BOLT, MACHINE - DOUBLE HEXAGON EXTENDED WASHER HEAD, CORROSION AND HEAT RESISTANT STEEL, UNS S66286, UTS 130 KSI MIN, .2500-28 UNJF-3A

AS9557™
SHEET 1 OF 3

REV. E

ISSUED 2000-08 REVISED 2017-11

FIGURE 1 - BOLT

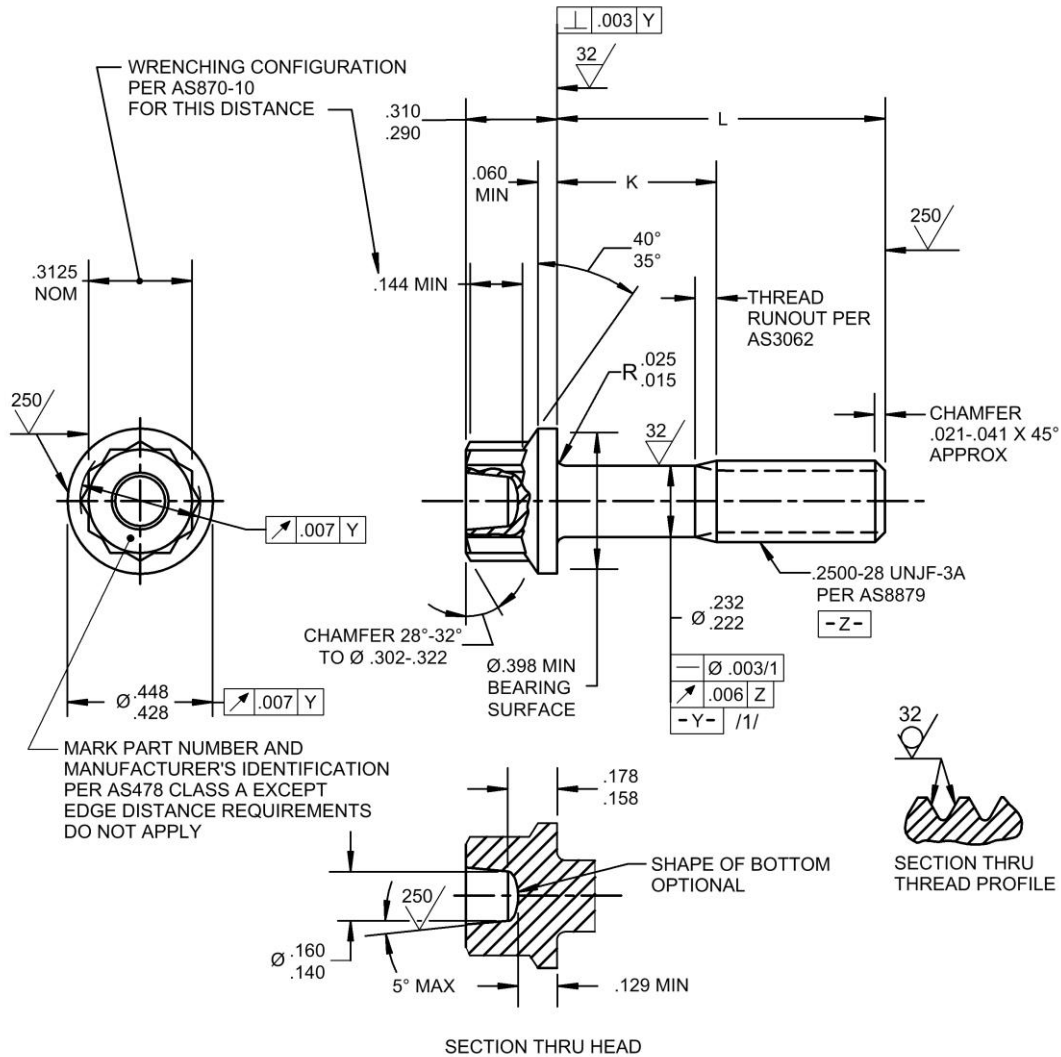
DELETE RADIUS AT TRANSITION OF WRENCH FLATS AND BASE FLANGE, ADD EXISTING INVENTORY DISPOSITION NOTE, ADD "MINIMUM" TO FPI SENSITIVITY LEVEL REQUIREMENT, COLD ROLLING NOTE - DELETE CURRENT NOTE 4 (SEE AS7477) AND INCORPORATE LENGTH EXCEPTION INTO NOTE 3, DELETE REGARDLESS OF FEATURE SIZE SYMBOL FROM STRAIGHTNESS FEATURE CONTROL FRAME, CORRECT TYPOGRAPHICAL ERRORS IN K DIM MAX FOR -34,-35, AND -52, FIGURE 1 REDRAWN, GENERAL EDITORIAL UPDATE.
